Joint Witness Statement (JWS) Expert Conferencing Table 3.11-1

Water clarity: Attachment 5

Craig Depree, Martin Neale & Bill Vant

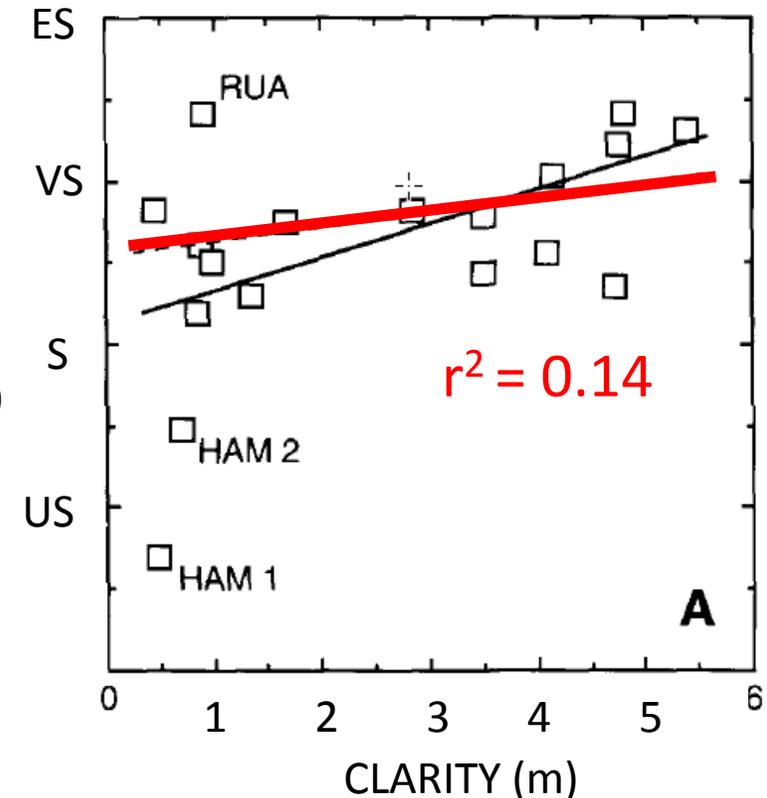
So why the need for a revised attribute?

- Concerns from experts in the sub-group
 1. Site 'grading' based on median (i.e. threshold only met 50% of the time)
 - alternative to require 90% compliance with threshold
 - **ALTERNATIVE 1** (Mr. Vant; Dr. Neale)
 2. technical basis of PC1 attribute that increased clarity = improved 'swimmability'
 - alternative to base attribute on % of samples exceed a single 'safe swimming' threshold
 - **ALTERNATIVE 2** (Dr. Depree)
 3. bottom-line values accounting for naturally turbid water bodies (e.g. Waipa)
 - Limited progress on this except for table 'footnotes' acknowledging bottom-line doesn't apply where site visual clarity is naturally low (i.e. <1m)

*Limited time to discuss and hence further develop an **alternative clarity attribute***

Summary / comparison

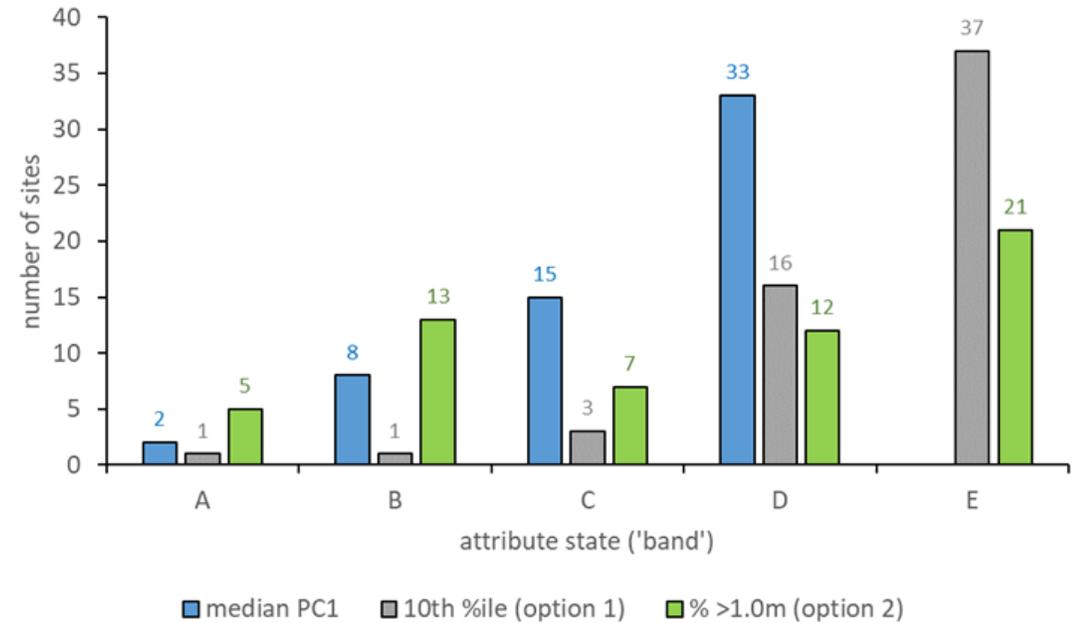
- expert agreement...
 - Alternative 1 = 2 (Mr. Vant; Dr. Neale)
 - Alternative 2 = 3 (Dr. Depree; Mr. Conland; Dr. Ausseil)
 - current PC1 = 4
 - (Dr. Cooper; Dr. Scarsbrook; Ms. McArthur; Mr Hall)
 - disagreed with all (Dr. Mueller)

- comparison table
